Factory Service Bulletin

BULLETIN: 845

SPRING RETURN PITCH WHEEL

Kit Part Number 997-044701-002 Smoked Grey w/serrated edge
(For Memorymoog)

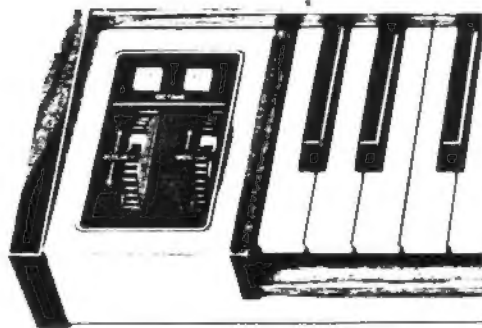
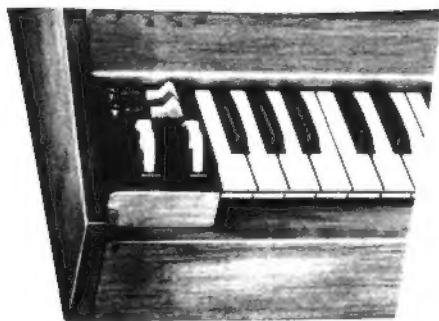
This is a non-warranty customer option modification changing the pitch wheel assembly. Installation is estimated to take 1/2 hour. It provides a quick return to zero of the pitch wheel for Memorymoog, Source, Taurus II, Rogue, Minimoog, Micromoog, Multimoog and Opus synthesizers.

Remove the existing pitch wheel assembly by removing the hardware securing the assembly to the housing. Transfer the wires from the original wheel assembly to the new one following the same wiring order and install using the original hardware. After installation, use a DVM and electrically center the new wheel to zero volts +/-100mv by loosening the set-screw inside the wheel with a 1/16" Allen driver and turning the pot shaft. Retighten the set screw and verify the wiper voltage is still zero volts.
